Historic Resources Board Staff Report (ID # 10822)

Summary Title: 840 Kipling Street: Additions and Modifications to a SOFA I

Title: PUBLIC HEARING / QUASI-JUDICIAL. 840 Kipling Street [18PLN-

00185]: Request for Historic Resources Board Consideration of Proposed Additions and Modifications to a Residence Previously Determined by the HRB to be a Contributing Resource Within the Boundaries of the SOFA I Coordinated Area Plan. The Project Request Includes Individual Review and a Variance for the Construction of a Second Story Addition on a Substandard Lot. Environmental Assessment: Exempt From the Provisions of the California Environmental Quality Act (CEQA) in Accordance With Guideline Section 15301 (Additions to existing structure). Zoning District: R-2 (Low-Density Residential). For More Information Contact the Project Planner

Rear (south) façade

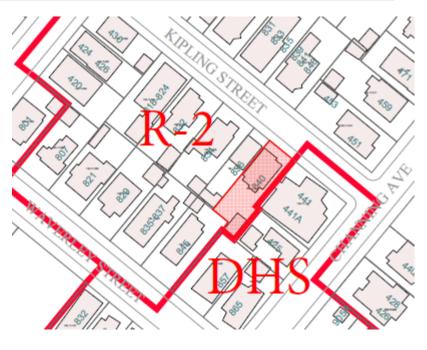
- The flat-roofed projecting portions (dated circa 1912-1924) at rear façade will be removed.
- The existing rear wood deck will be removed.
- A one-story addition will be constructed at the rear façade.

- The rear addition has a partial hipped roof at the east side and a gabled roof form at the west side.
 - Paired fully glazed aluminum-clad wood doors with aluminum-clad wood sidelites and transoms will be installed at the gable roof portion of the addition.

- All historic material at the cornice at edge of the rear (south) façade roof will be removed.
- New exterior stairs will be added at the southwest corner of the residence and will
 provide access to new partial basement below the rear addition.
